LOUP POWER DISTRICT

June 1, 2015

Subject: Loup River Hydroelectric Project
Comments on USFWS' Draft Biological Opinion
FERC Project No. 1256-031

115
 116 Figure 2. Central Plate River least tern and piping plover nest incidence 1978-2013 by year and habitat
 117 type. Asterisks indicate periods when monitoring effort changed significantly.

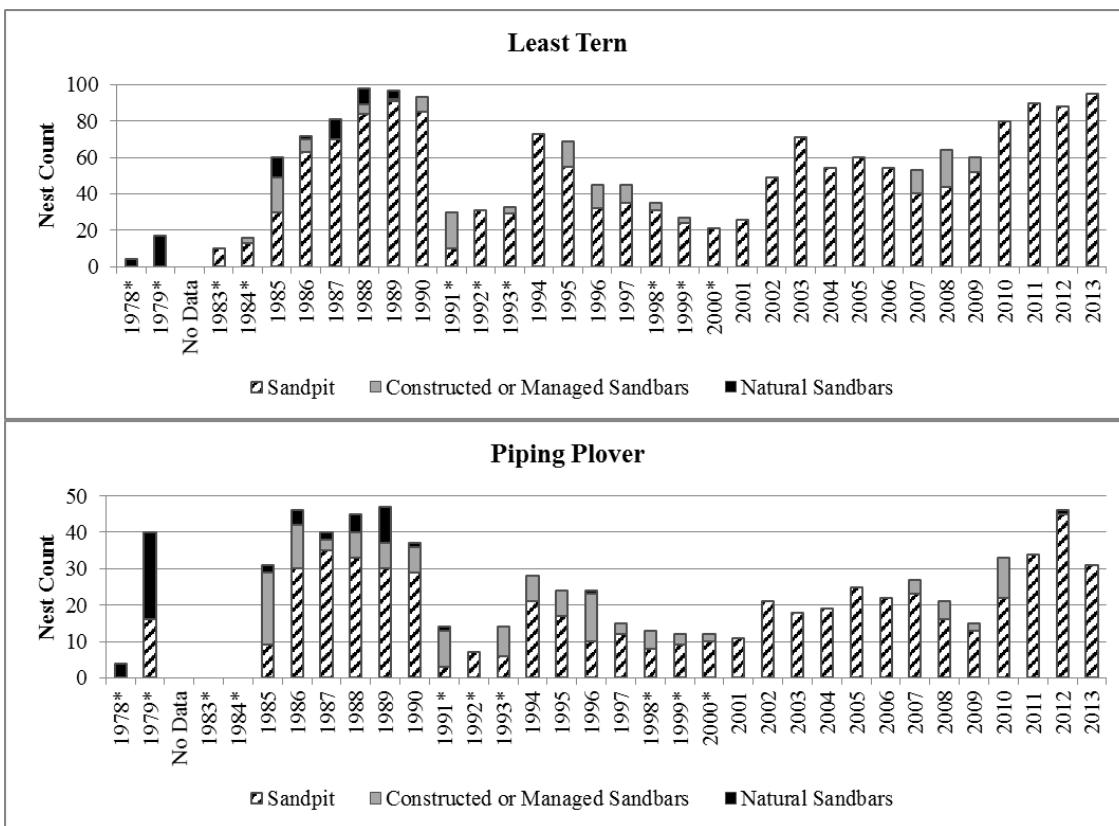
Line 109, 8.5% figure for least tern nests does not match table. Also, it is apparent in Figure 2 that natural sandbars were used very rarely after ~1990 and constructed/managed sandbars were used only sporadically; it may help to note briefly here whether there was a lack of availability or lack of selection of those habitats leading to those results and heavy use of sandpit habitat, to provide context for the numbers.

51 **Figure 2:** Adaptive management cycle.

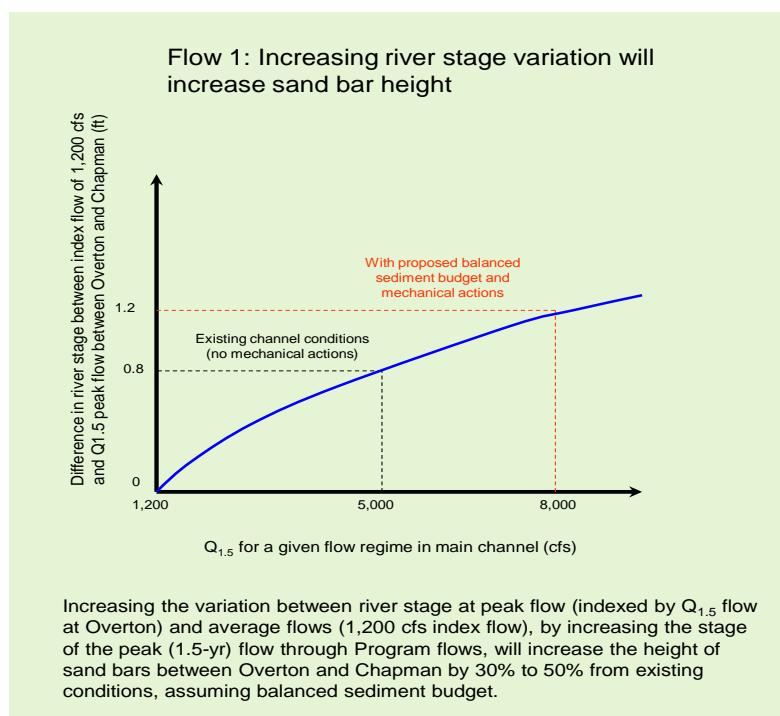
The adaptive management (AM) cycle shown in Fig 2 of Chapter 2 may be too simple, as it does not include the three levels of intervention possible: targeted research (to better define the problem and possible interventions - ie to decrease uncertainty), pilot projects (to test out possible approaches, further decreasing uncertainty), and full-scale implementation (once uncertainty is low enough to make large investments). These appear in the AM cycle as presented by Michael Healey² of UBC (Figure 1). Unfortunately the only version of this I have is from the CALFED Ecosystem Restoration Strategic Plan, but I can try to track down a better citation for it once my computer is fixed and I am back in the US with a reliable internet connection.

290
291 Figure 12. Stage-discharge and mean sandbar height relationships in comparison to the Program's
292 minimum height suitability criterion of 1.5 ft above 1,200 cfs stage. The extrapolated sandbar height 1.5 ft
293 below peak stage is based on observations following the 2010 high flow event.

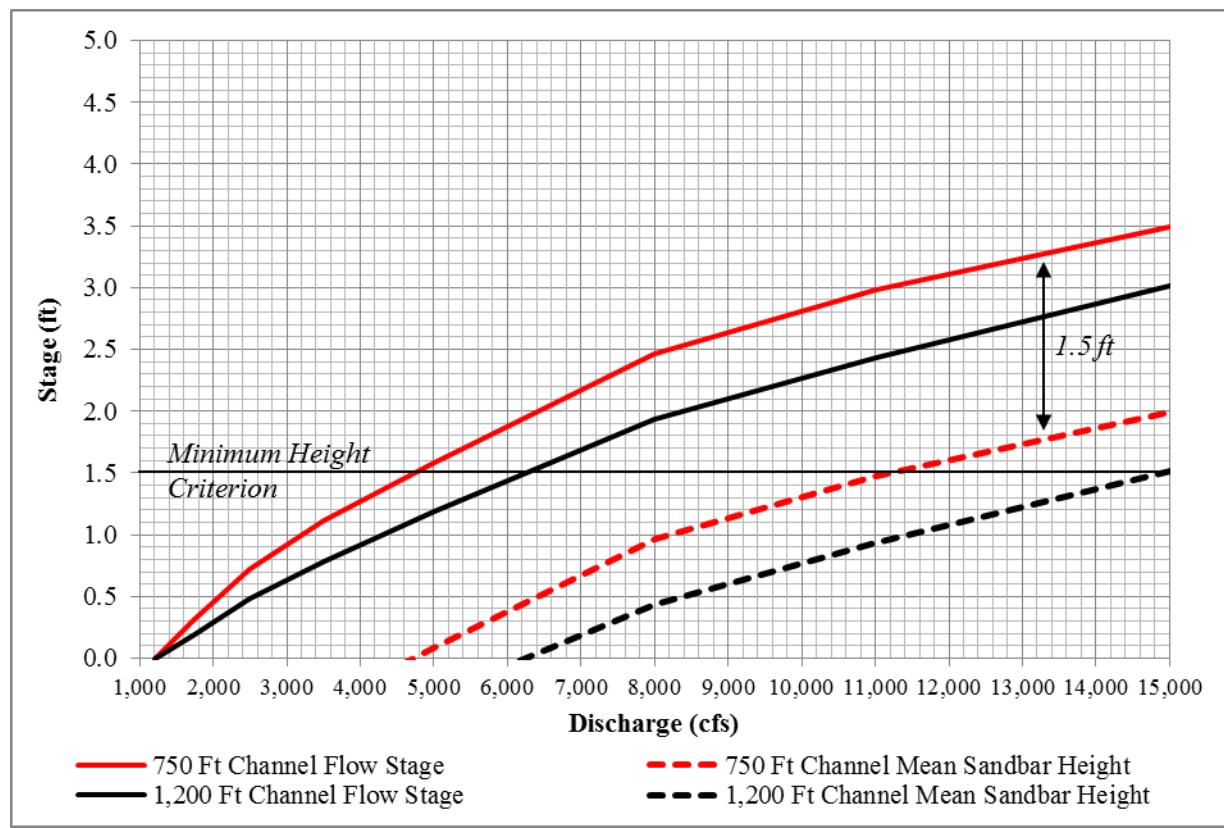
Figure 12: This figure would benefit from a more detailed explanation. My interpretation of the figure is that, given the stage-discharge relationships developed from the HEC-RAS models (initially presented in Figure 5), and then a single data point of the sandbars formed in 2010 with a three-day mean peak discharge of 8,200, with the remainder of the dashed-line curves extrapolated from the difference of that single observation. The extrapolated curves suggest what sandbar elevation may result from different peak discharges of similar duration, though it is not stated what the degree of certainty might be in the extrapolations and if there is evidence for the assumption that the relationship between peak flow and sandbar height would be constant for the range of flows. If this interpretation is correct, it may help to provide a more detailed explanation for the reader, and possibly indicate the empirical data points at the 8,200 flow to assist with interpretation.

Chap 3, Figure 12 and similar references: Rather than "750 ft channel" say "750-ft-wide channel", etc

| Comment ID # | Chapter/Section | Page # | Line # | Reviewer | Comment | PRRIP Response |
|--------------|-----------------|--------|---------|--------------|--|--|
| 94 | 3 | 19 | 289 | Matt Kondolf | Figure 12 and similar references: Rather than "750 ft channel" say "750-ft-wide channel", etc | Noted. |

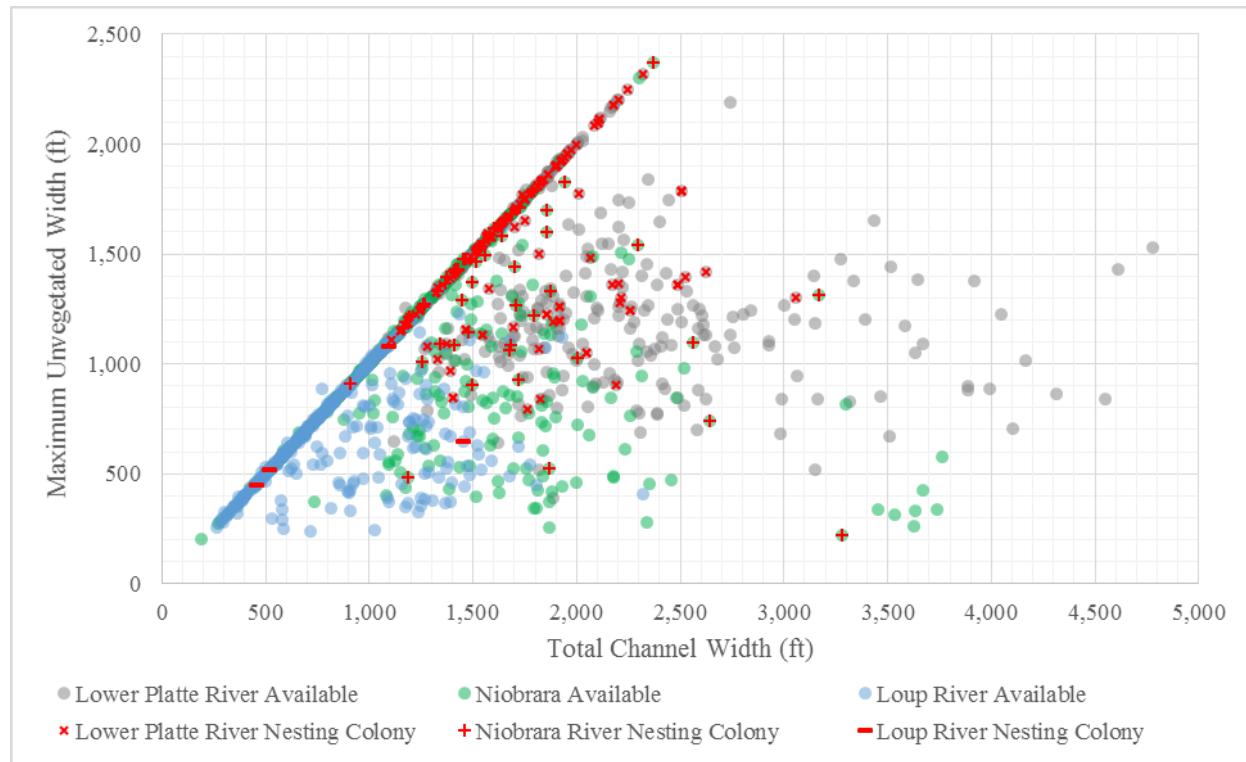
Figure 5 caption: second sentence is ambiguous: available locations from 2012 only and nesting colonies for all years?

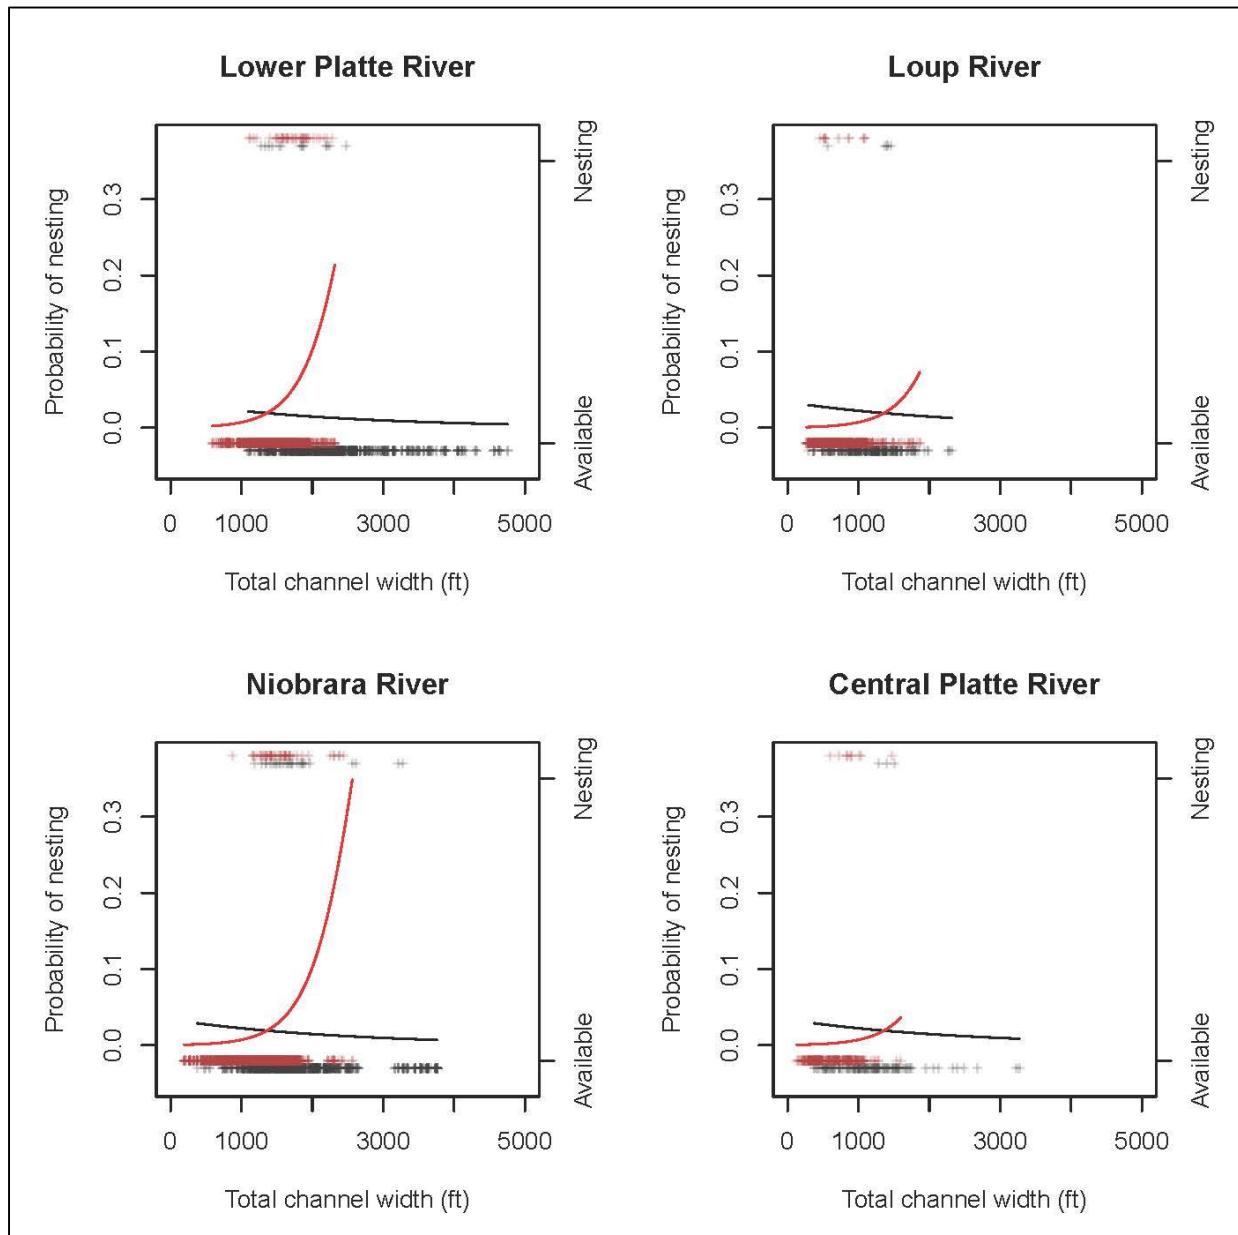
Figure 6: Are these plots using the best-fit model that does not include river segment?

Chap 4, Figure 6 For lower right diagram, modify label as "Central Platte River (excluding AHR)"
